CITY OF ALBUQUERQUE

**Re: Lot 11 Block 8 SAD 228
Volcano Cliffs Subdivision Unit 22
6316 Canavio Rd. NW
Grading and Drainage Plan
Engineers Stamp Date 1/20/2022 (D10D003E11)
Pad Certification Date 3/21/2022
CO Certification Date 1/18/2023**

DRAINAGE AND TRANSPORTATION INFORMATION SHEET (REV 6/2018)

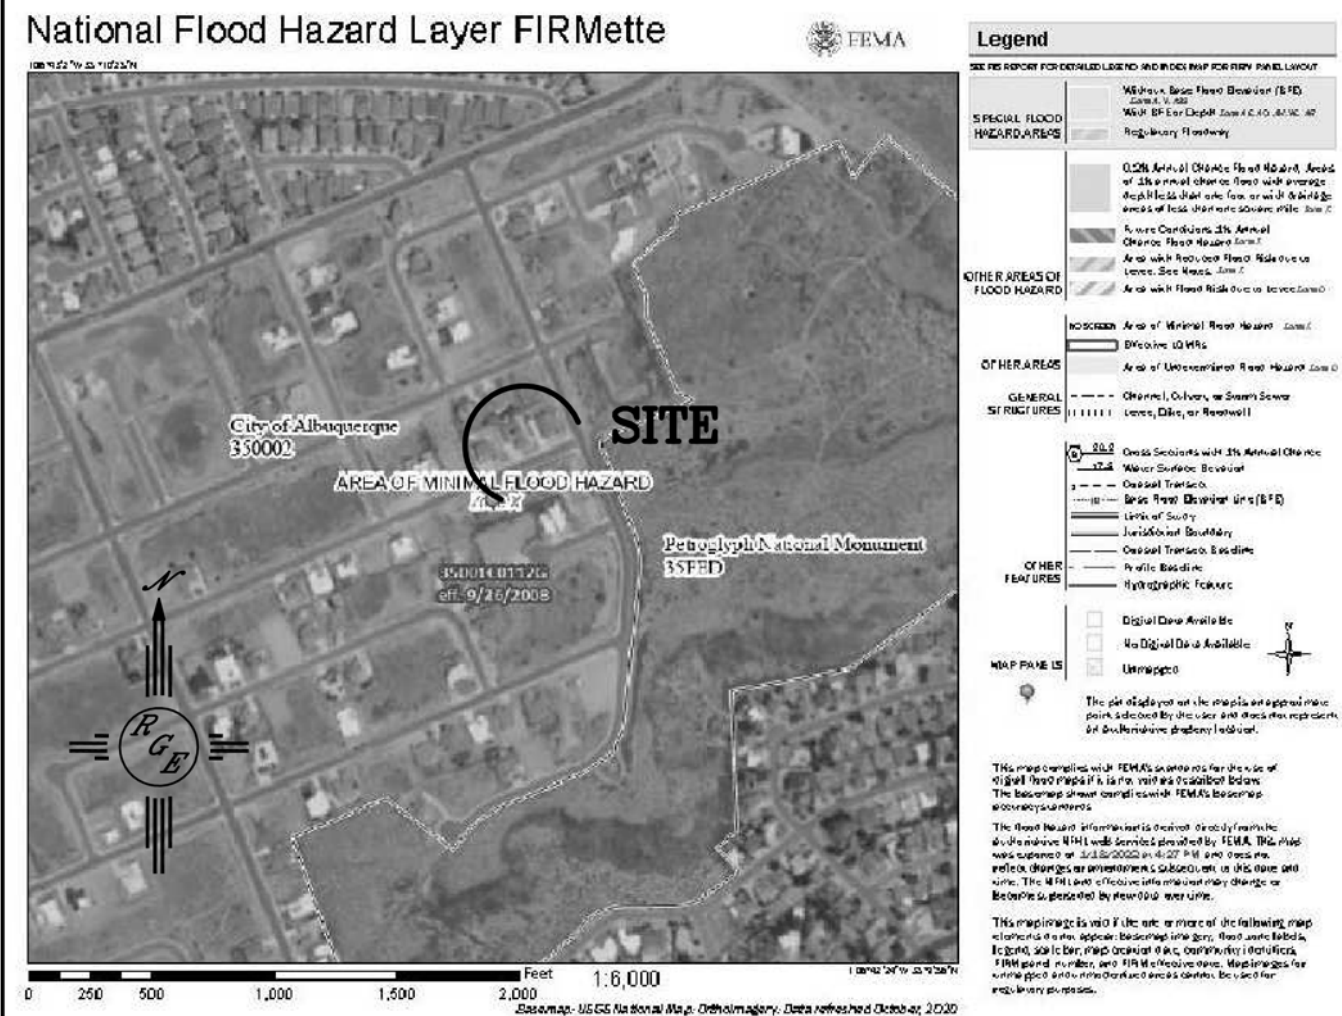
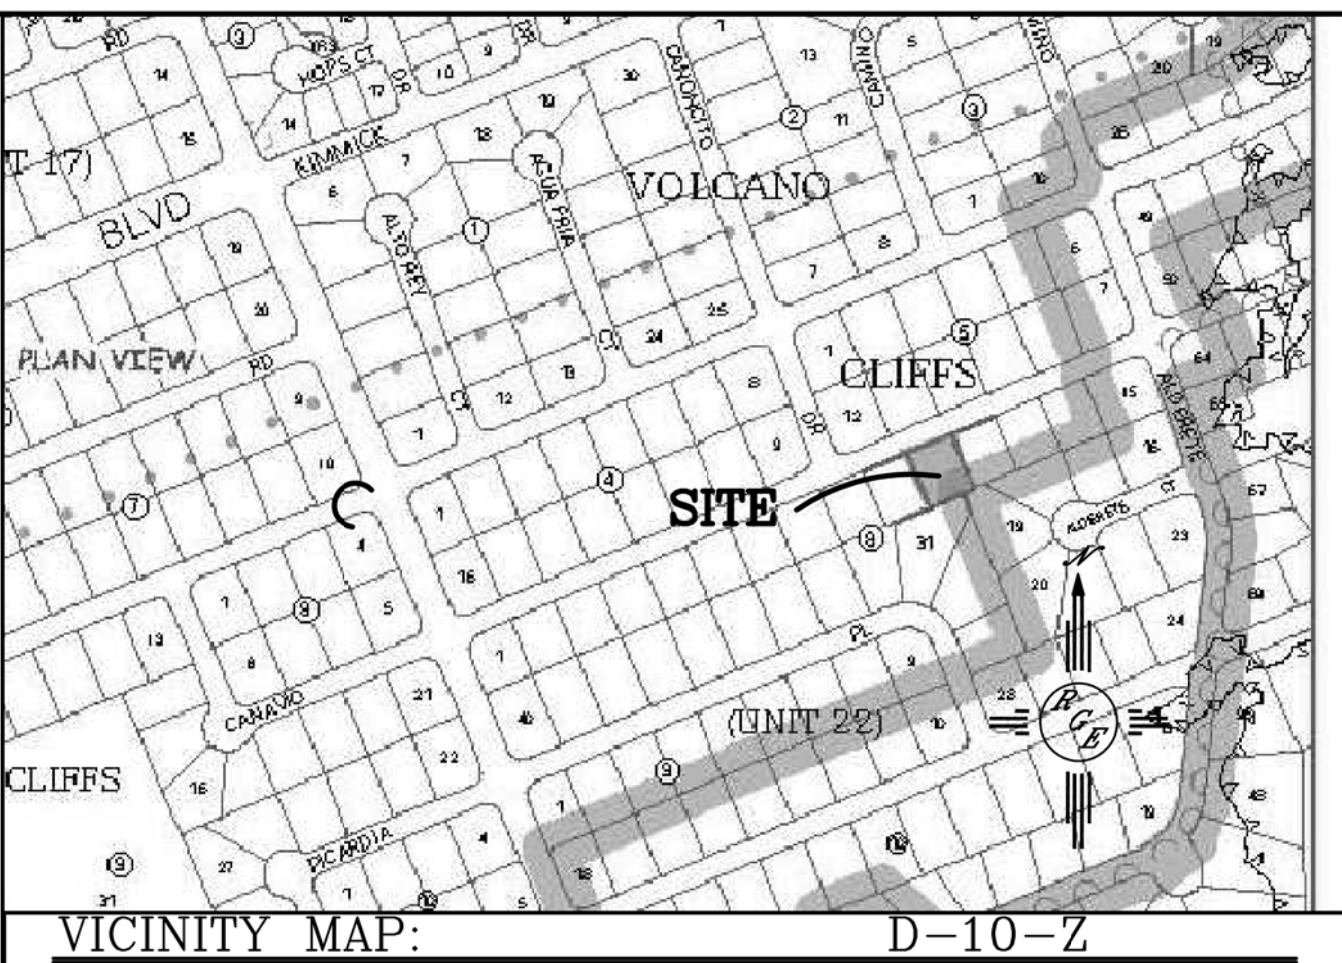
- All ponding areas and swales need to have gravel in place.
